BMW Motorrad Service Information Bulletin

****Recall 06V-164 - Retrofitting Banjo Bolt w/Restrictor****

Subject: Retrofitting banjo bolt with restrictor

Model: K 1200 S (K40), K 1200 R (K43), with Integral ABS
R 1200 GS (K25), R 1200 RT (K28), R 1200 RT (K26) with Integral ABS

Fig. 1: New banjo bolt with restrictor is a hex head design. (K - Model shown)

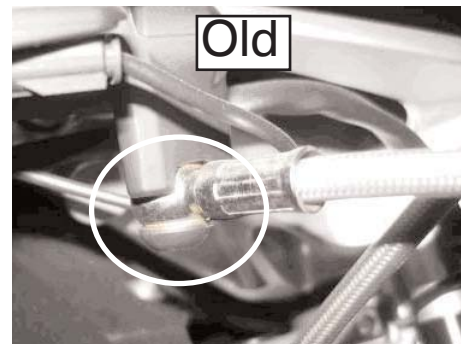
Production Solution: A new banjo bolt with a restrictor is now being installed in the handlebar fitting in series production (see Fig. 1). This banjo bolt incorporates a calibrated orifice plate that limits the increase in pressure and counters the possibility of excessive pressure building up in the Integral ABS system.

Fig. 2: Old banjo bolt is a 'torx'. (K - Model shown)

Aftersales Solution: Motorcycles already produced will have to have the banjo bolt with restrictor retrofitted.

1. Gently pull the brake lever until the blow-by bore in the brake master cylinder is passed.
2. Secure the brake lever in this position.
3. Remove the original banjo bolt and install the new banjo bolt with restrictor (tightening torque 18 Nm). Hold the end of the brake hose up to prevent brake fluid from escaping and air from making its way into the system.
4. Now bleed the system by gently operating the brake lever. Make sure that the motorcycle is propped on its **side stand**; if necessary also move the handlebars from left to right. The advantage of this procedure is that it is not necessary to bleed the modulator.

Fig. 1: New banjo bolt with restrictor is a hex head design. (R - Model shown)

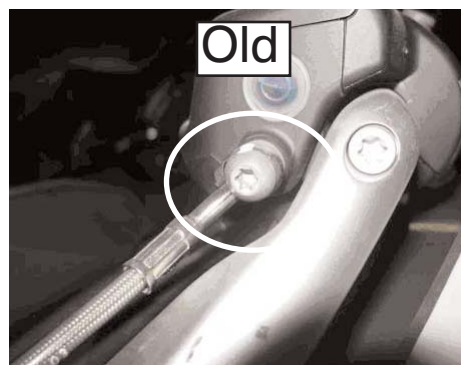
Fig. 2: Old banjo bolt is a 'torx'. (R - Model shown)
